CHARLOTTE - MECKLENBURG
PLANNING COMMISSION

SUBJECT: Administrative Approval for Petition No. 98-49 by The Everett Company.

SARDIS COURT TOWNHOMES
 R.H. HAGEMeyer, INC.
 CHARLOTTE, NORTH CAROLINA
 PETITION NO. 98-49

ORNAMENTAL FENCE 1
NOT TO SCALE
DATE: AUGUST 17, 2001
DPR PROJ NO. 01051.1

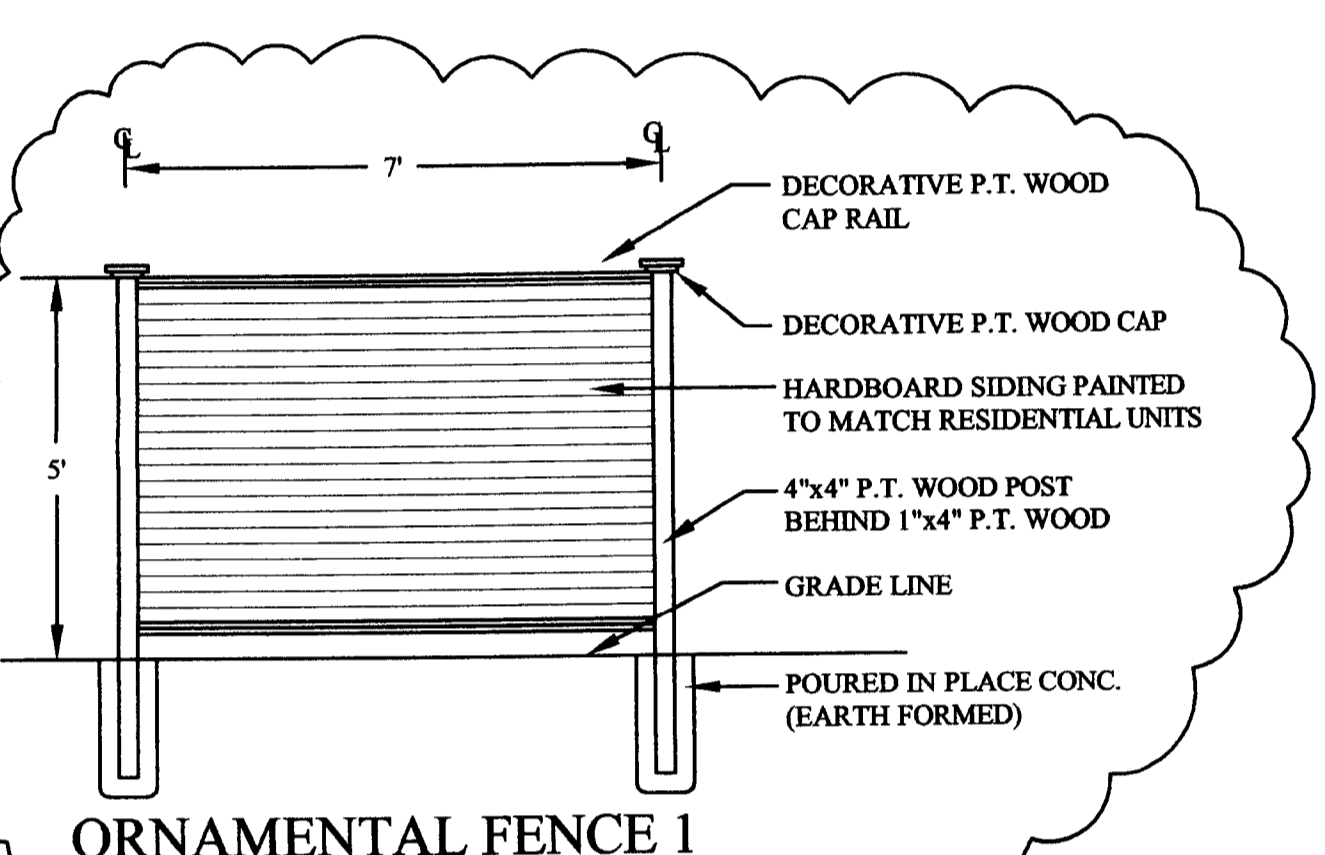
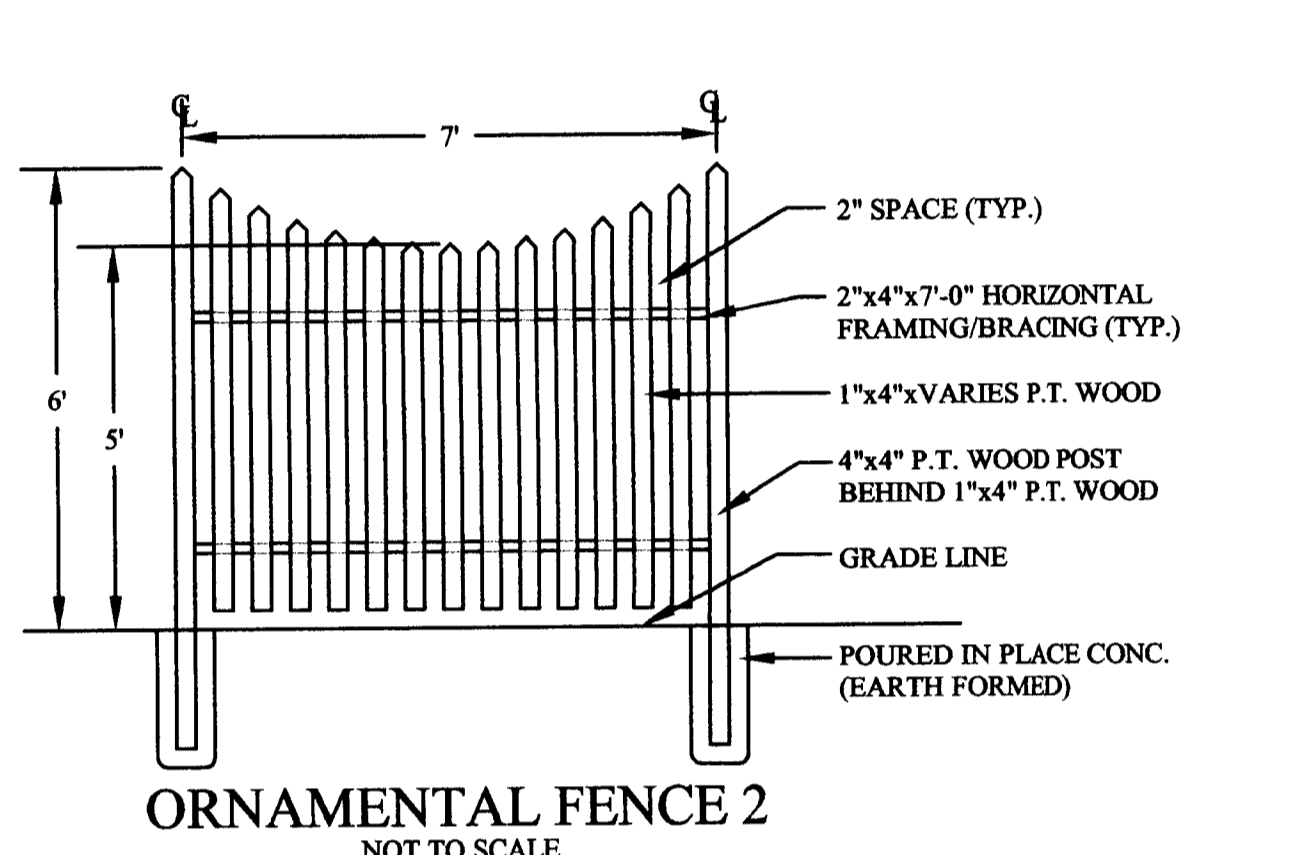
Attached are revised plans for the above referenced petition. The plans have been revised to reflect a reduction in units, to add a fence along Sardis Road, to revise streetscape plantings along Sardis and reflect changes to the building elevations. These changes are considered minor and do not alter the intent of the originally approved plan therefore, I am administratively approving these plans. Please use these plans when evaluating requests for building permits and certificates of occupancy.
